SERVICE BULLETIN No. 6647-32-13

LANDING GEAR - EXTENSION AND RETRACTION - CONTROL AND INTERFACE

LANDING GEAR CONTROL AND INTERFACE UNIT - AMENDMENT 8

INTRODUCTION OF A NEW MICROPROCESSOR BOARD, OUTPUT BOARD, POWER SUPPLY AND FILTER ASSEMBLY and POWER SUPPLY MODULE

Figure 1 – Part View of Back Face of Rear Support (PNR: 001-LG-01-0820)

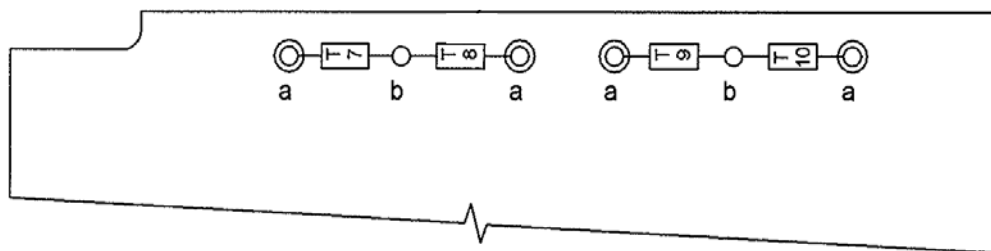
- (10) Refer to Figure 1 below. Find Tranzorbs T7, T8, T9 and T10 (320) attached to the back face of the Rear Support Panel (235). Tag and identify location of all grey single core wiring soldered to the Tranzorbs and the single black multicore wire soldered the "T7B" terminal. Also make a note of the routing followed by each wire. Unsolder the grey single core wiring attached to the Tranzorbs and the black multicore wire attached to the "T7B" terminal. Also unsolder the black multicore bonding wire link between the "B" terminals and keep. (Note: The grey wires are a part of the unit wiring loom and the black multicore wire soldered to the "T7B" terminal is the earth bonding wire to the bonding tag on the structure of the Filter Panel Assembly, see paragraph 3. B. (17) below.

- (1) Take new Rear Support Assembly (PNR: 001LG010820). Refer to Figure 1 above and the black multicore bonding wire link removed in Paragraph 3. B. (10) as a template. Using a 80 mm (3.15 inch.) length of black wire detailed in Paragraph 2. C. (2) (b), solder a bonding wire link between "B" terminals. Take the four new Tranzorb (PNR: 2826318608) and solder Tranzorbs in positions T7, T8, T9 and T10 to tags on back face of the Rear Support Panel. Bond the Tranzorb body to the Rear Support using adhesive sealant detailed in Paragraph 2. C. (2) (b). (Note: The adhesive is a damping mechanism between the Tranzorb body and panel. The Tranzorbs T7, T8, T9 and T10 are to be conformally coated using items detailed in Paragraph 2. C. (2) (b) above. Allow the adhesive sealant and conformal coating to dry in accordance with manufacturers instructions.

Figure 1 – ESS Test Profile

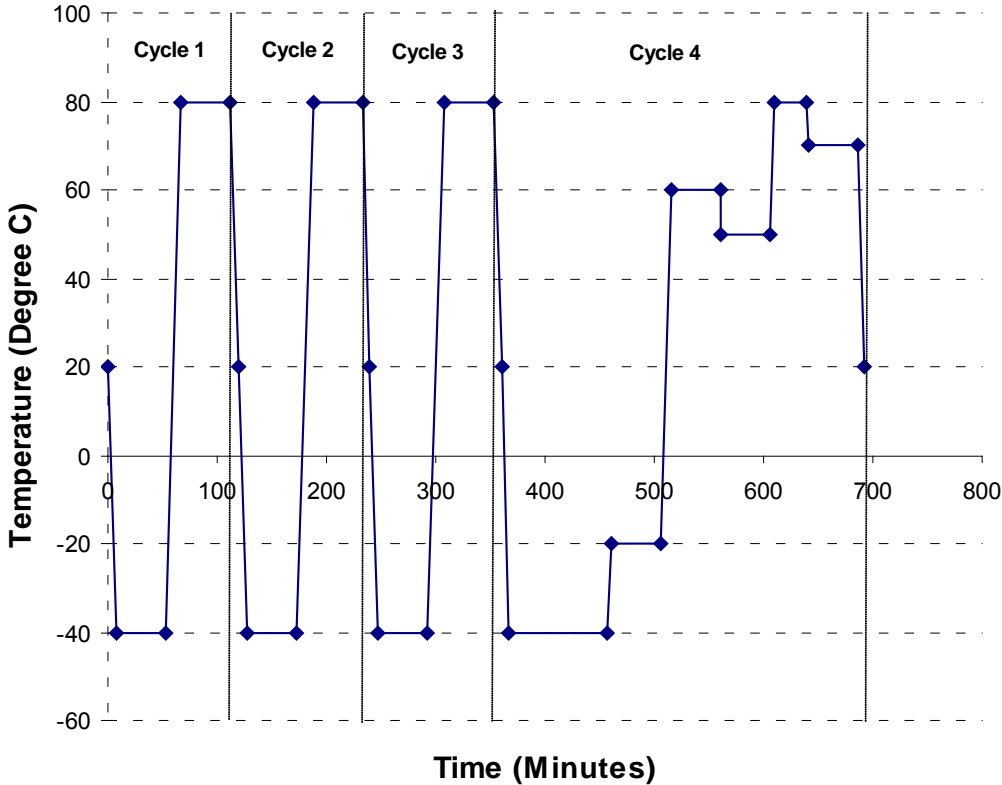
Refer to this Appendix 1, Figure, the LGCIU (whilst powered/not powered) shall be subject to an Environmental Stress Screening (ESS) of combined temperature cycling and vibration over 4 cycles with a total screening time of approximately 11.5 hours. The environmental test facilities will need to be set-up using the information provided below.
